UNITED STATES PATENT AND TRADEMARK OFFICE

APPLICATION NO.	FILING DATE	FIRST NAMED INVENTOR	ATTORNEY DOCKET NO.	CONFIRMATION NO.
09/540,113	03/31/2000	Wolfgang Renz		2414

**DETAILED Non-Final ACTION**

U.S. Patent Oct. 28, 1986 Sheet 2 of 2 4,620,155

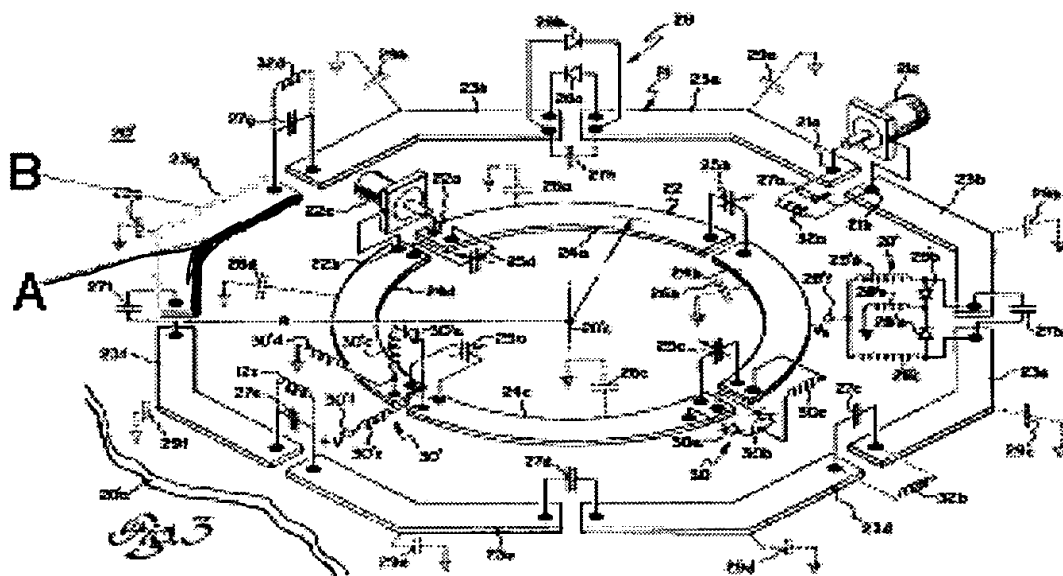
Tenth Edition 1997 "developing uniformly around a central axis", and the components of **Edelstein** meet this conventional well-known definition of radial. The **Edelstein** reference shows that the antenna elements are arranged "radially relative to a center axis so as to proceed outwardly from the respective element beginnings (i.e. inner surface A) "to the respective element ends"; (i.e. outer surface B) [See Figure 3] "and exhibit cyclical symmetry from antenna element to antenna element;" [See Figure 3] The examiner notes that each of the "said antenna elements" (i.e. the segmented elements 23a-h) have an inner surface A and an outer surface B "being at least magnetically coupled with each other;" [See Figure 3, col. 2 lines 18-51] "and said plurality being at least five" [See Figure 3 which shows at least 8 segmented antenna elements].

11 The examiner notes that using the definition for radial as "developing uniformly around a central axis" the, **Ed Istein** reference meets the requirements of claim 1,

because components 23a through 23h are developed uniformly around a central axis represented by point 20'c in Figure 3.

12 With respect to **Claim 2**, **Edelstein** shows and suggests that “the respective element beginnings (i.e. surface A in Figure 3) “and the respective element ends” (i.e. surface B in Figure 3) are also connected to ground”. [See Figure 3 components 29a through 29h] The same reasons for rejection, that apply to **claim 1** also apply to **claim 2**.

13 With respect to **Claim 3**, **Edelstein** shows, teaches and suggests that “said antenna elements are electrically coupled to each other.” [See Figure 3, components 23a through 27h; col. 4 lines 13-29; and the entire reference in general.] The same reasons for rejection, that apply to **claim 1** also apply to **claim 3**.

14 With respect to **Claim 8**, **Edelstein** shows, and suggests from the diagram of Figure 3, that “the respective element beginnings define an element beginning plane and wherein the respective element ends defines an element end plane, and wherein said element beginning plane and said element end plane are parallel to and spaced from each other.” [See Figure 3] The same reasons for rejection, that apply to **claim 1** also apply to **claim 8**.

15 With respect to **Claim 9**, **Edelstein** shows, and suggests from the diagram of Figure 3, that “the respective antenna elements are linear.” [See Figure 3] The same reasons for rejection, that apply to **claims 1, 8** also apply to **claim 9**.

16 With respect to **Claim 10**, **Edelstein** shows, and suggests from the diagram of Figure 3, that “the respective antenna elements define respective line directions, said

line directions intersecting said center axis at a common point", [See Figure 3 center point 20'c which is the center of angulated ring 23 and inner ring 24. Additionally, Figure 3 suggests that all the segmented components have the same central axis point.] The same reasons for rejection, that apply to **claims 1, 8**, also apply to **claim 10**.

17 With respect to **Claim 11**, **Edelstein** teaches, shows, and suggests from the diagram of Figure 3 "a grounding plate disposed parallel to said element beginning plane and said element end plane, and said common point being disposed in said grounding plate." [See Figure 3]. The same reasons for rejection, that apply to **claims 1, 8, 10** also apply to **claim 11**.

18 With respect to **Claim 12**, **Edelstein** teaches, shows, and suggests, from the diagram of Figure 3, a "grounding plate disposed parallel to said element beginning plane and said element end plane." [See Figure 3] The same reasons for rejection, that apply to **claims 1, 8**, also apply to **claim 12**.

19 With respect to **Claim 13**, **Edelstein** shows, and suggests, from the diagram of Figure 3 that the plurality of angulated antenna segments is 8, and a plurality of 8 angulated segments is inherently "divisible by 4". Therefore, **Edelstein** teaches, shows, and suggests, that the plurality of antenna segments "is divisible by 4". The same reasons for rejection, that apply to **claim 1**, also apply to **claim 13**.
